Surface Mount

Apple recently made some updates to their iPad product line back in September and announced the iPad 7th gen. 10.2 - inch. This new iPad is the same high and length as the iPad Air 3rd gen. 10.5 - inch, **HOWEVER** it is 1.4mm thicker. Also the camera locations shifted slightly. As a result we needed to make a few changes to our existing product line to accommodate the thickness of the new iPad.

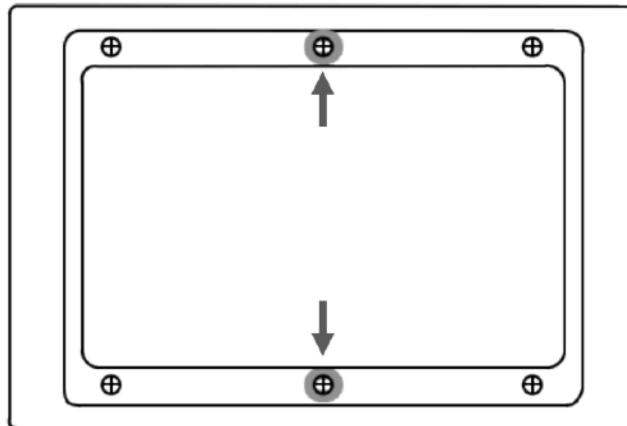
New IPORT packaging; The New packaging will identify the new compatible iPad versions (iPad 10.2-inch (7th gen) | iPad Air 10.5-inch (3rd gen)).

Addition of new fit pads to accommodate the thickness of the iPad 7th gen and Air 3rd gen.
